Bulletin | Danfoss Turbocor Compressors

Customer Notification

B-CN-272-EN REV A

SUBJECT: IGV Feedthrough Clamp Orientation

Figure 1 – Feedthrough Connector Clamp

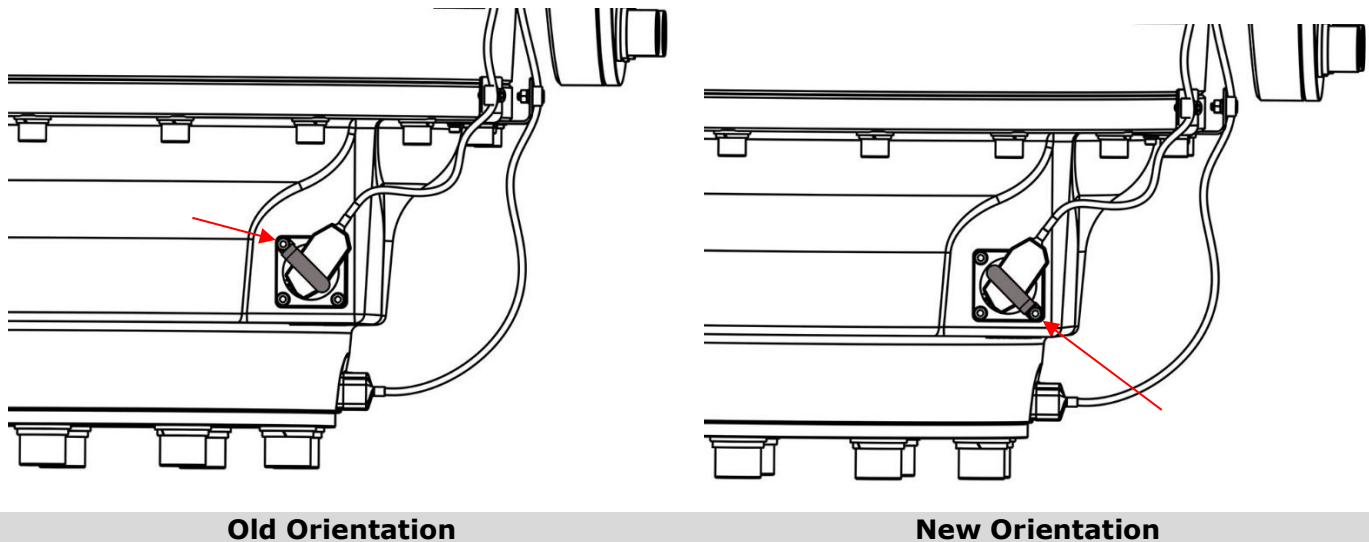
The purpose of this bulletin is to inform our customers that we have changed the orientation of the IGV feedthrough connector clamp on our VTX Compressors. Figure 1 below illustrates the old and new position of the IGV feedthrough connector.

The change of the location of the clamps was simply done to avoid the clamp catching on the packaging material when unpacking the compressor.

Our production VTX compressors have the new orientation of the IGV feedthrough connector clamp.
